ADDENDUM NO. ONE
WARREN WOODS PUBLIC SCHOOLS
HAWTHORN EARLY CHILDHOOD CENTER
RENOVATIONS
Page 1 of 2 (write up only)

March 6, 2015

ADDENDUM NO. ONE to the plans and specifications for the WARREN WOODS PUBLIC SCHOOLS, HAWTHORN EARLY CHILDHOOD CENTER, RENOVATIONS, Architect's Project No. 141596, dated February 23, 2015.

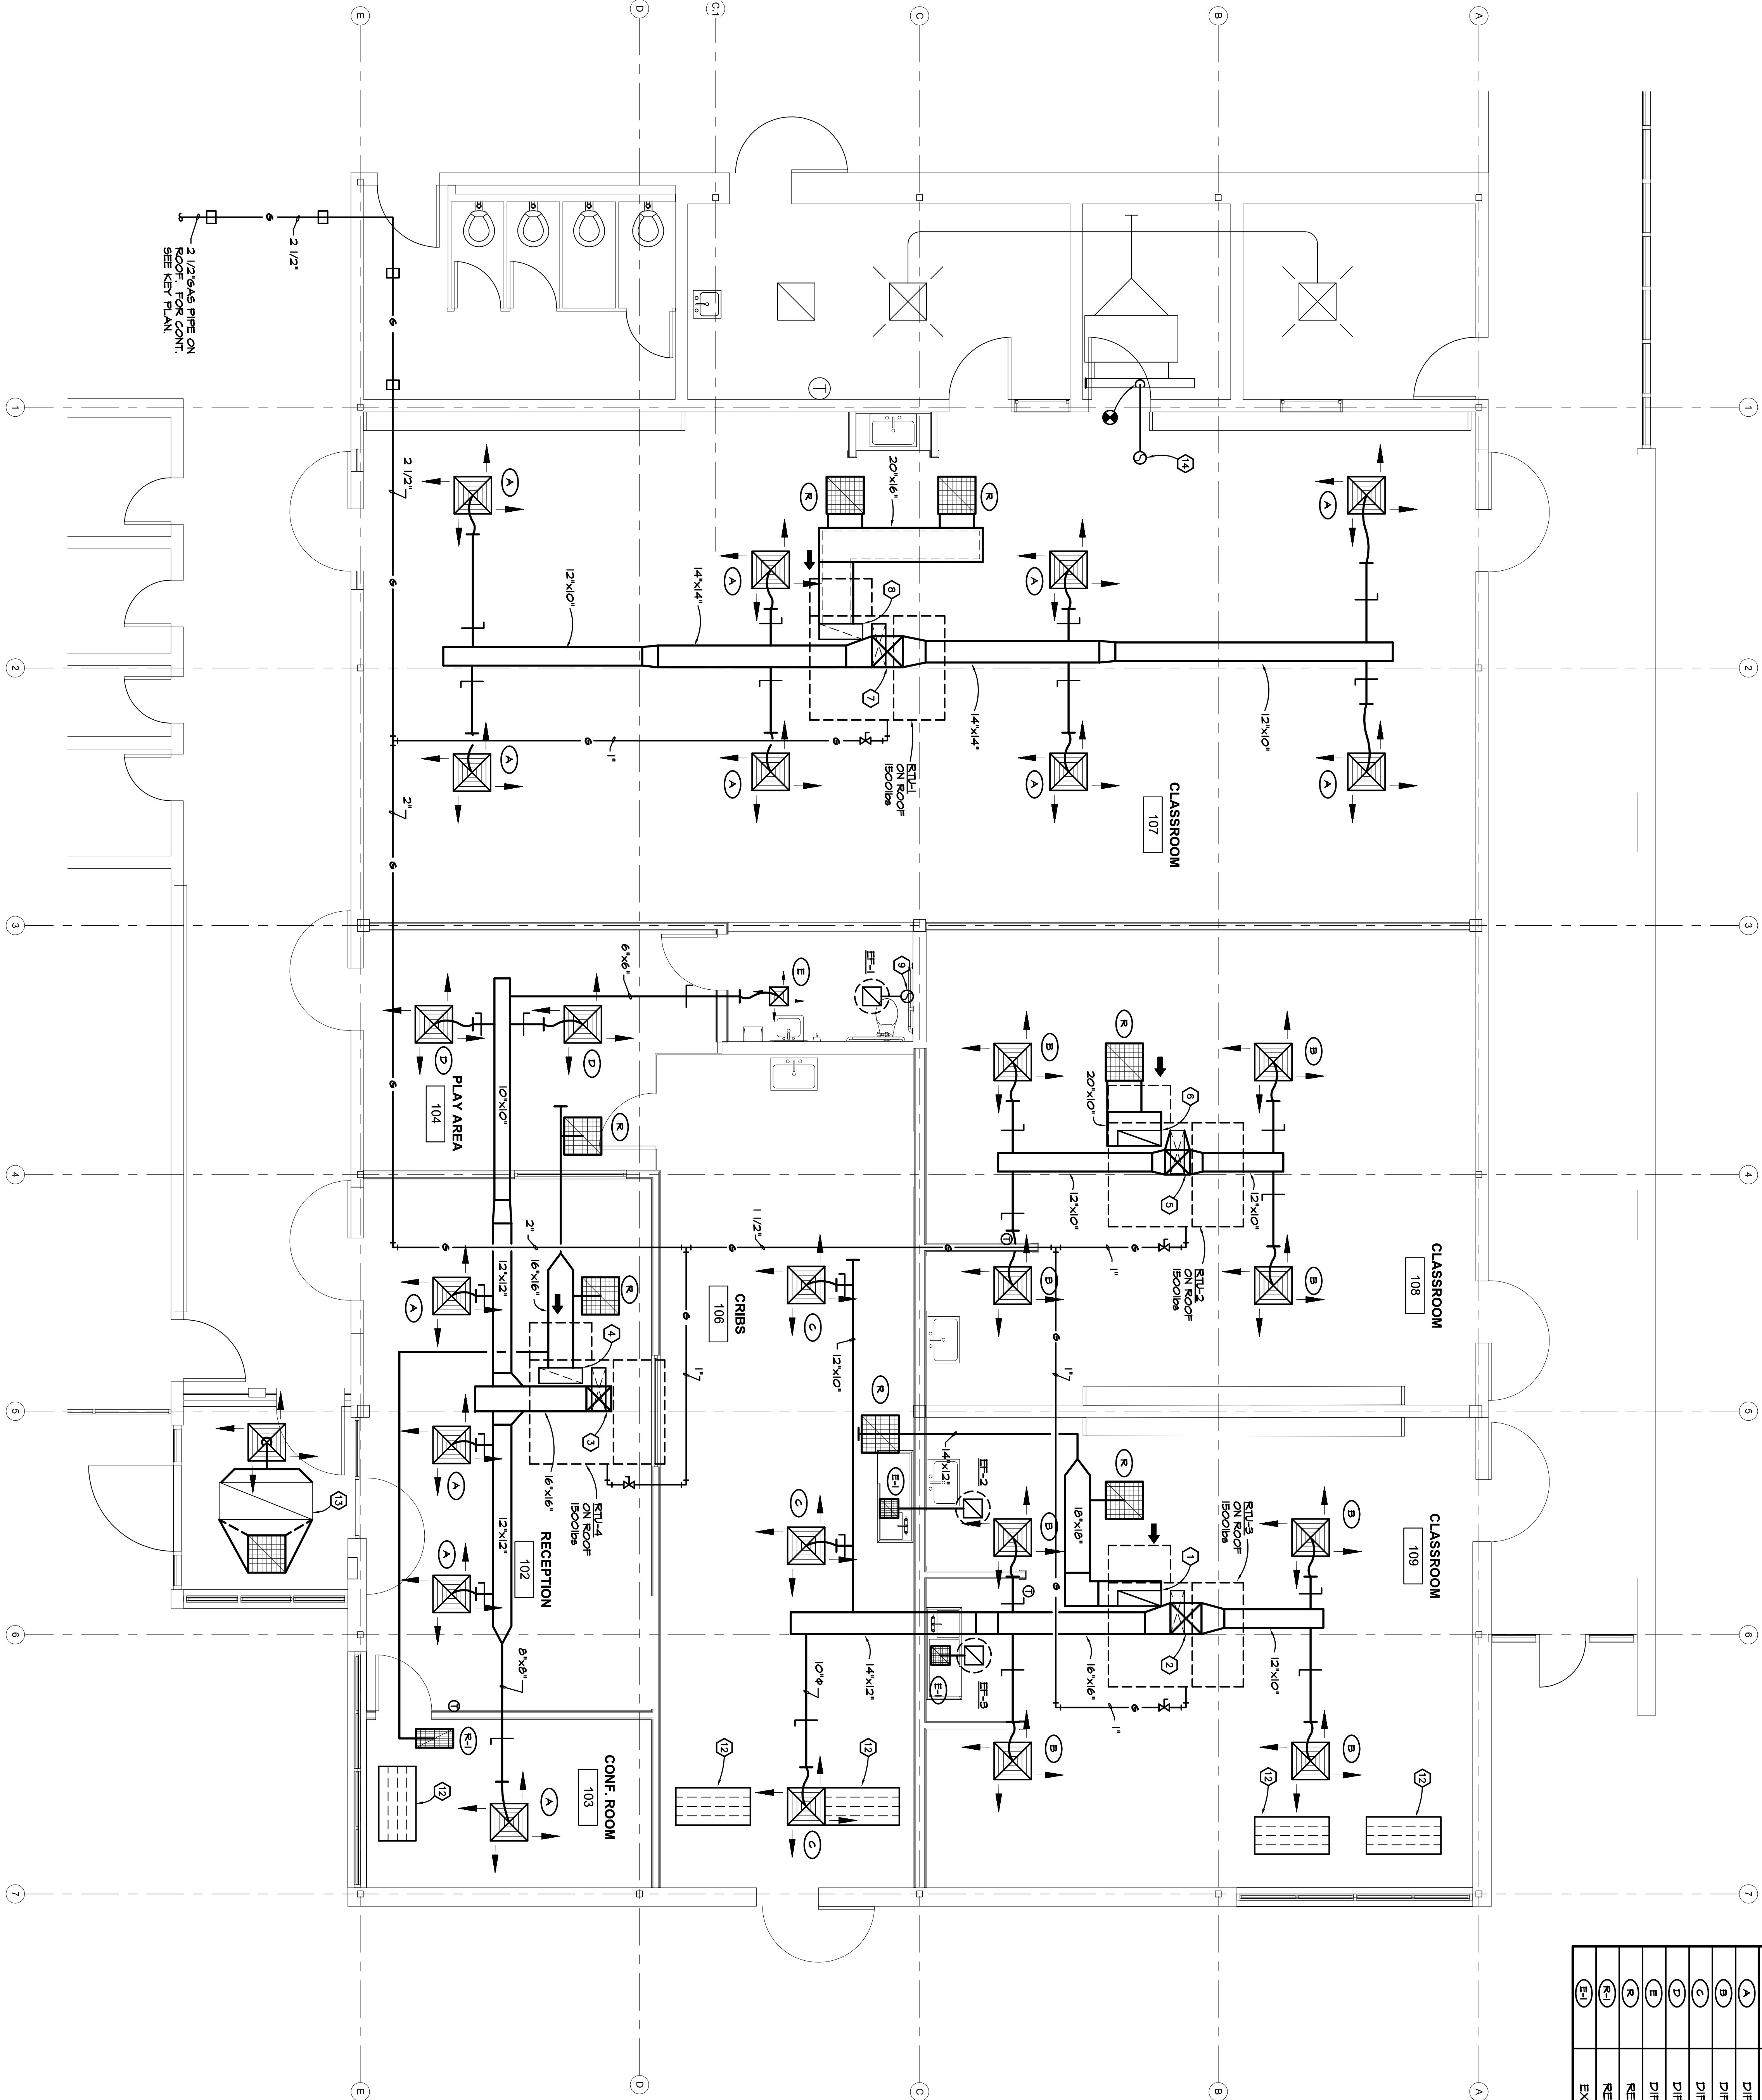
- ITEM NO. M1:** Refer to Drawing M1.2 (reissued):
- a. Added gas piping to the roof top units.
- ITEM NO. M2:** Refer to drawing M1.3 (reissued):
- a. Added two sinks (S-1) and all connecting pipes.
- ITEM NO. M3:** Refer to drawing M1.4 (reissued):
- a. Revised specifications for sink (S-2) and water closet.
- ITEM NO. M4:** Existing BMS is based on Novar System and is serviced by Rob Shepard at Technical Energy Solutions 616-583-6000 X 18, 616-813-6866 Cell.
rob.shepard@techenergysolutions.com
